SERVICE BULLETIN

OIL - OIL TANK ASSEMBLY - ADD A BRACKET FOR SECURING THE DUST COVERS LANYARDS -
CATEGORY CODE 6 - MOD.ENG-79-0022

V2500-ENG-79-0022

Brackets installation
Fig.1

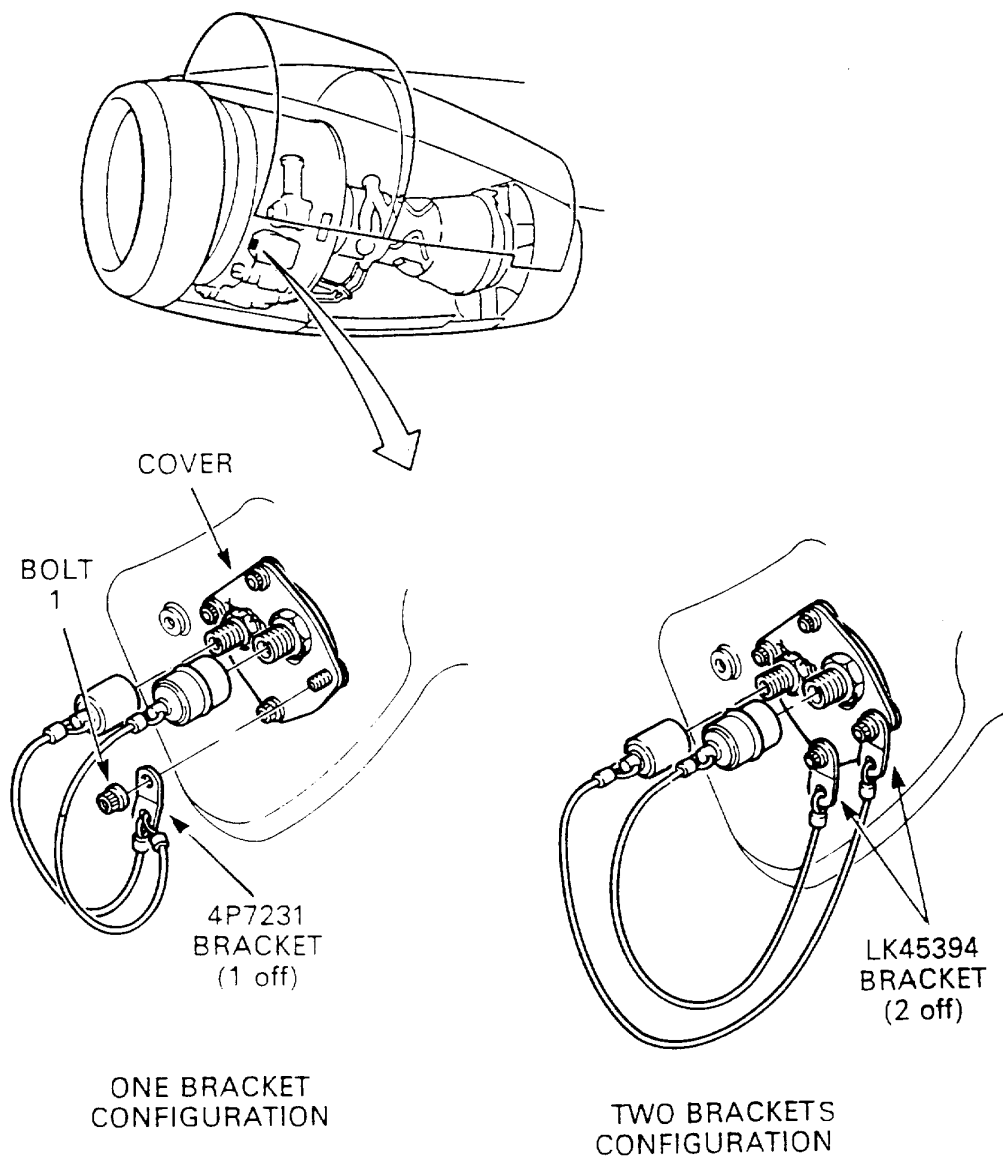
The existing oil tank introduced by Service Bulletin V2500.ENG-79.0014 does not have a dedicated bracket to secure the dust covers lanyards.

To add e bracket to secure the lanyards of the pressure fill/overflow coupling dust covers to the oil tank.

- (a) To provide from engine V0075 to engine V0135 two brackets to secure the dust covers lanyards.
- (b) To provide, from engine V0136 onward, a new bracket featuring a bigger hole to permit the two lanyards to be secured at the same point.
- (c) The one bracket configuration is interchangeable with the two brackets configuration; only the one bracket configuration will be supported.
This service bulletin has been issued for information only; all the engines listed in the effectivity section of this S.B. have been already modified to the two bracket configuration

- (1) Loose but not remove the four bolts that attach the cover to the oil tank. Refer to Figure 1
- (2) Remove PN 4W0163, Bolt (1) from the cover and retain the bolt.
- (3) Center PN 4W7231, Bracket on the cover bolt hole and install the old PN 4W0163, Bolt (1). Tighten the bolt by hand.
- (4) Torque the four bolts to 85 to 95 lbfin (9m,604 to 10,734 Nm) (See in Reference (3) Chapter/Section 70-41-00 Torque Tightening Technique)
- (5) Connect the two dust covers lanyards to the bracket.
